**TOWN OF ERIE  
PLANNING COMMISSION MEETING  
December 2, 2020**

**SUBJECT:**           **General Business:**  
Redtail Ranch Sketch Plan

**PURPOSE:**       Review and comment on a Sketch Plan application for a residential subdivision proposing 898 residential lots.

**Sketch Plan Development Data:**

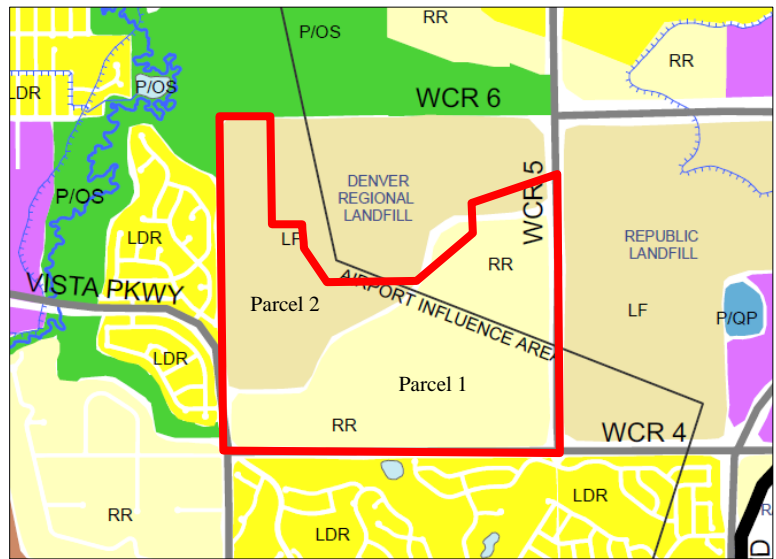
Town of Erie Parks and Recreation staff has concerns on the Neighborhood Park location shown adjacent to the contamination site and are recommending relocation. Parks referral comments shall be taken into account regarding this concern with a future Preliminary Plat application.

There are three existing oil and gas facilities within the sketch plan area. The applicant has depicted the 350-foot residential lot setback and 150-foot right-of-way setback appropriately. A future Preliminary Plat application will require all Surface Use Agreement elements to be depicted on the plat such as easements, setbacks, buffers, access roads, etc.
